PLAN OF LAND
IN
NEWBURYPORT, MA
SHOWING
PROPOSED SITE IMPROVEMENTS
AT
2-6 MARKET STREET
(MAP 47 - LOT 59)

Subject: 2-6 Market Street Response to Engineering Review Comments

In response to design review comments provided by Phil Christiansen and Jon-Eric White, we have prepared the following responses. Please note these address outstanding issues. All previously addressed issues are not included.

EXISTING CONDITIONS
SHEET: C-1

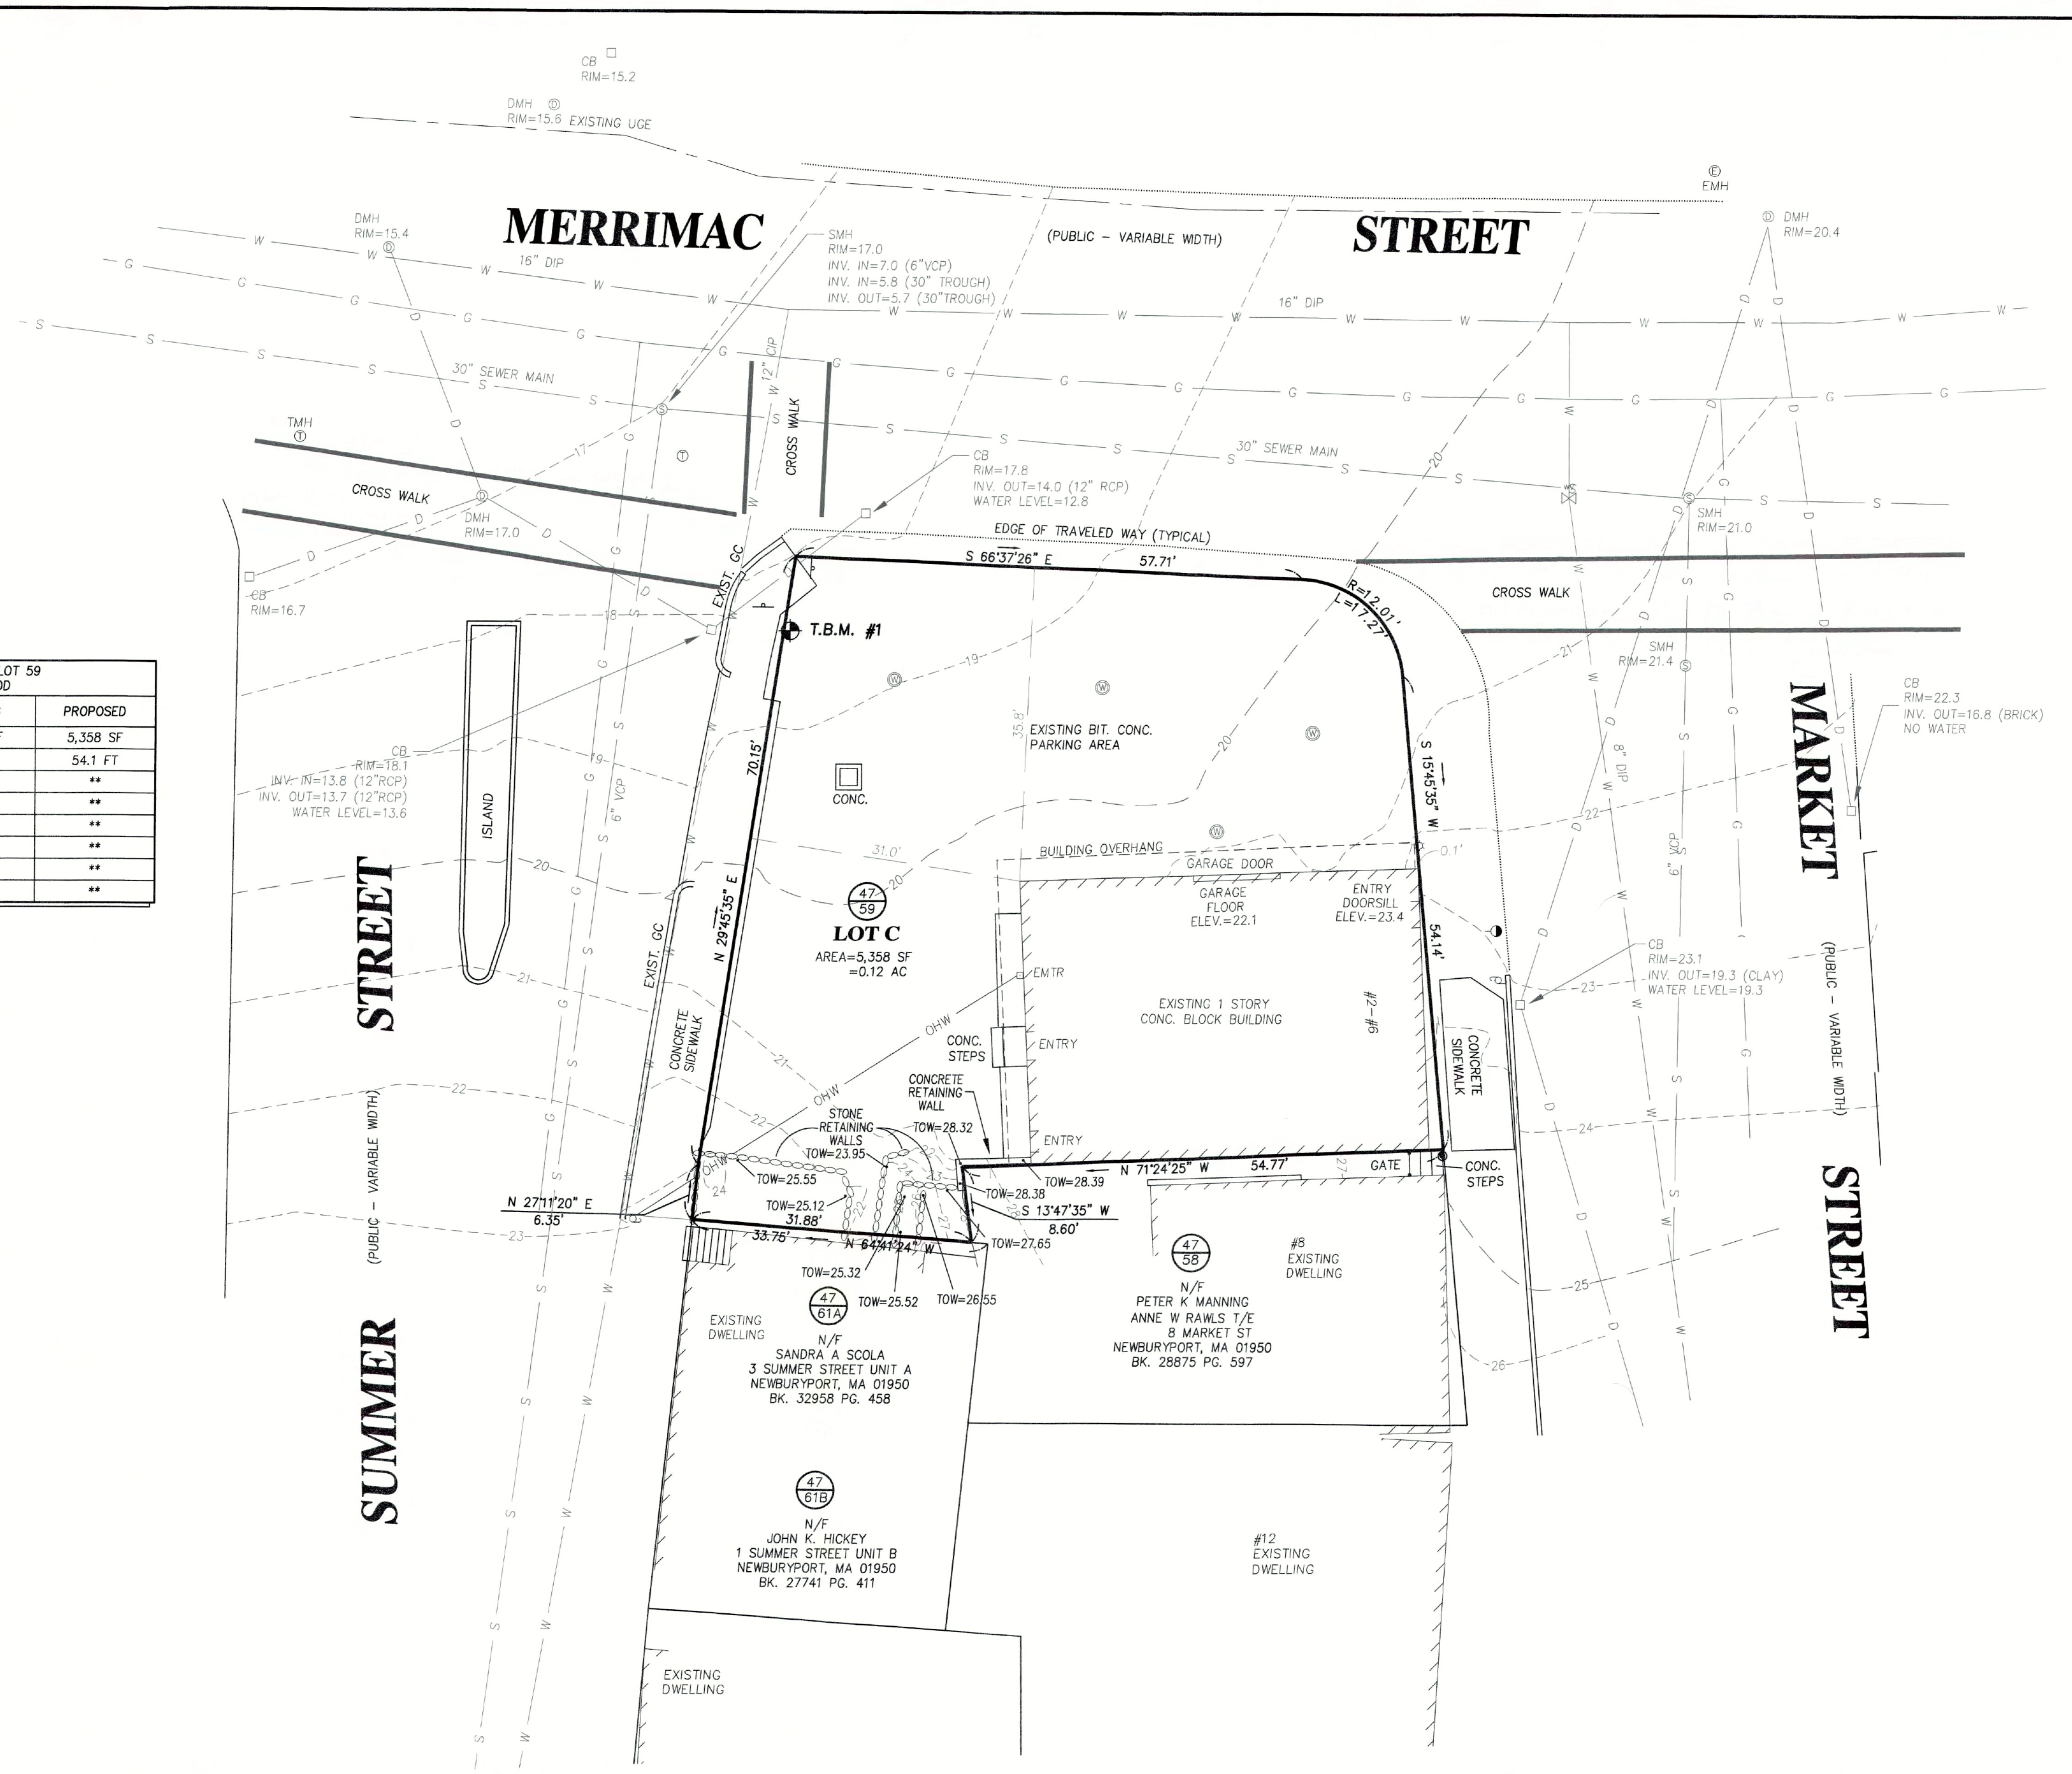
As stated by the engineer spot grades and utilities have been added to the plan. The catch basins in Merrimac and Summer Streets are shown to connect into a sewer junction that is within the cross walk of Summer Street. A sewer manhole is shown within Merrimac Street northeast of the cross walk labeled SMH, Rim = 17.0. The engineer should clarify if the SMH is misplaced and should be located within the cross walk or if its location is correct and the sewer shown in Merrimac Street should be tied into it.

Response: As mentioned above, the existing utilities have been updated. They were incorrectly labeled on the previous plans.

SITE PLAN

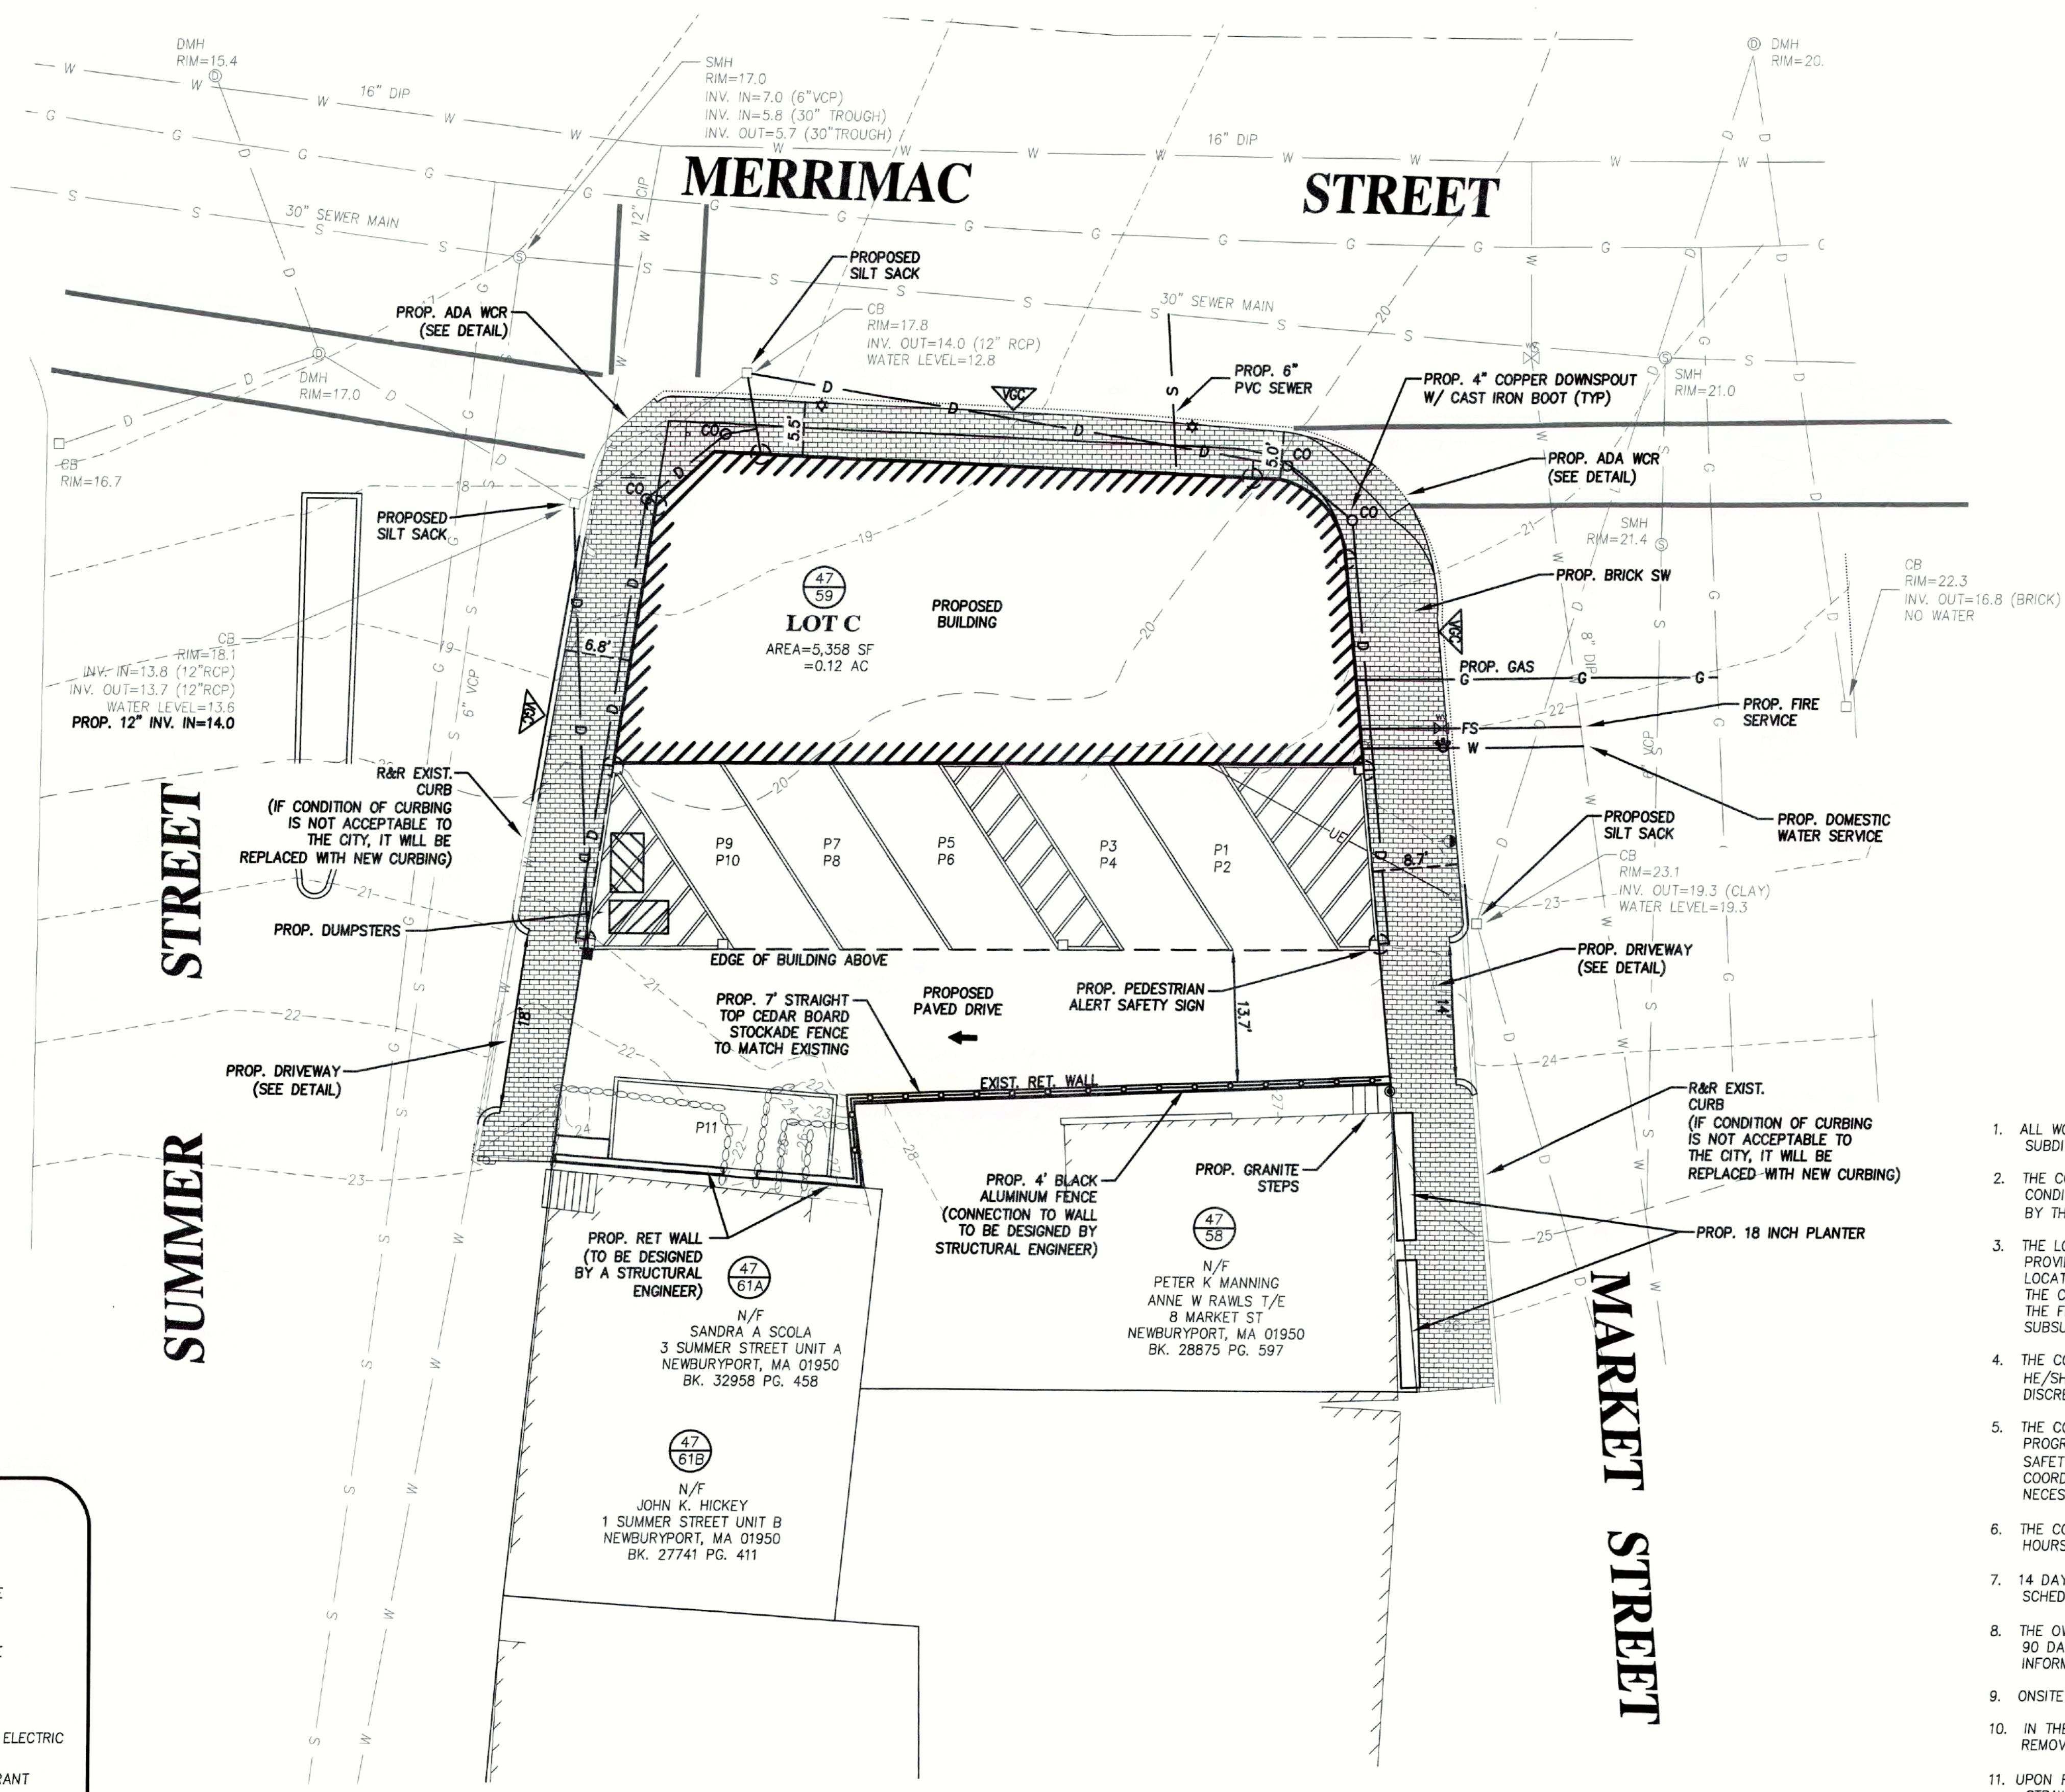
Sewer, water, drain and gas proposed locations are shown on the revised plan. Electric is not shown. Will it be overhead or underground?

The plan should specify if all of the curbing shown on the plan is proposed to be new or if existing curb is to be left in placed or reset.

Ramps for Handicapped access should be shown.

The brick sidewalk should be shown.

The paved areas on site should be labeled.

The lamp posts locations should be shown.

The snow removal note is not on sheet 5.

Response: Underground electric has been added to the plans (see sheet C-2).

Response: It is the intention to reuse all of the existing curbing which has now been labeled as remove and reset (R & R). However, if it is found that the condition of the existing granite is not acceptable to the City, it will be replaced with new curbing.

Response: Ramps have been added to the plan (see sheet C-2).

Response: Brick sidewalks have been added to the site plans (see sheet C-2).

Response: The paved areas have been labelled (see sheet C-2).

Response: Lamp post locations have been added to the plans (see sheet C-2).

Response: The note has been added to the plans stating that snow will be removed from site in accordance with all local, state, and federal regulations (see note 10, sheet C-2).
